Keystone RV Company

SERVICE ADVISORY # 25-474

Underslung Axle Tank Clearance

Fig. 1

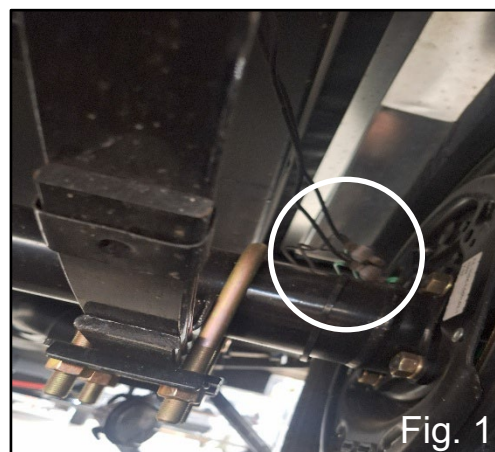
It has been determined that certain models with underslung axles may have insufficient clearance between the axle beam and the holding tank located above the axle. The lack of clearance may cause damage to the holding tank. The following procedure describes how to correct the issue.

The remedy is to verify that the unit is affected, remove and replace the underslung axle with an overslung axle to provide adequate clearance for the holding tank. Replace the single step with double steps on units that apply.

Disconnect the wiring from the brake backing plates. Make note of how the wires connect to the unit as they will be reconnected in a later step. (See Fig.1)

Remove the existing AP axle kit hardware. Remove the existing underslung axle from underneath the unit. (See Fig. 2 – Fig. 3)

Install the overslung axle using the new AP hardware kit. (KRV # 600065 - Axle – A/P Kit – Single – Wax Flange Nuts) in the same manner as the previous AP hardware was installed. (See Fig. 2 – Fig. 3)

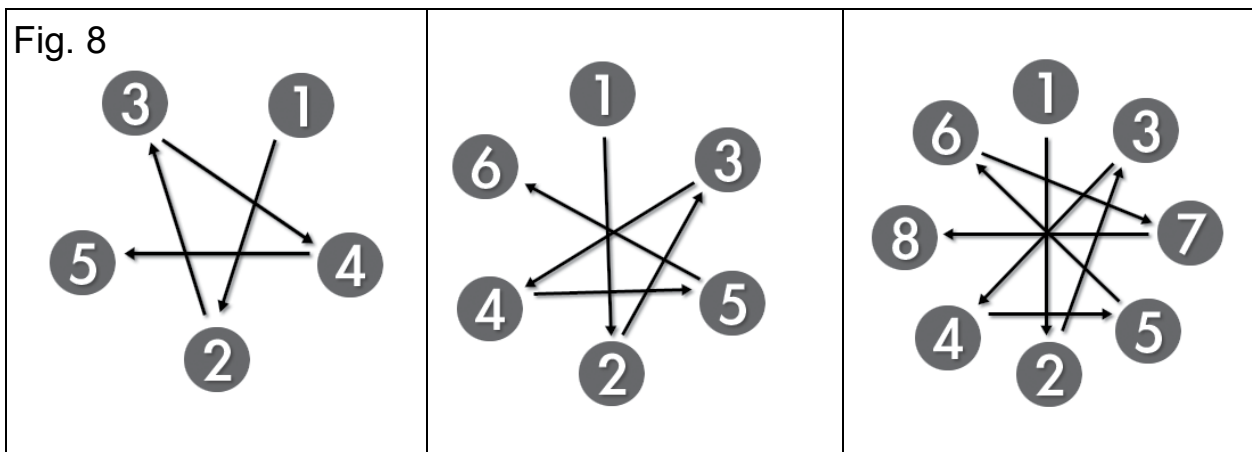
You must use the star pattern and torque wrench when tightening the lug nuts to the wheel. This sequencing pattern shows how to progressively tighten the lug nuts to best achieve the proper torques and clamp load. (See Fig. 8)

Using the star pattern outlined in Fig. 8, tighten the lug nuts until the 1st stage torque (20-25 ft/lbs.) Verify the lug nuts are properly positioned in the tapered seats of the wheel. (See Fig. 9)

Using the star pattern outlined in Fig. 8, tighten the lug nuts until the 2nd stage torque (50-60 ft/lbs.) (See Fig. 9)

Using the star pattern outlined in Fig. 8, tighten the lug nuts until the 3rd and final stage (110-120 ft/lbs.) (See Fig. 9)
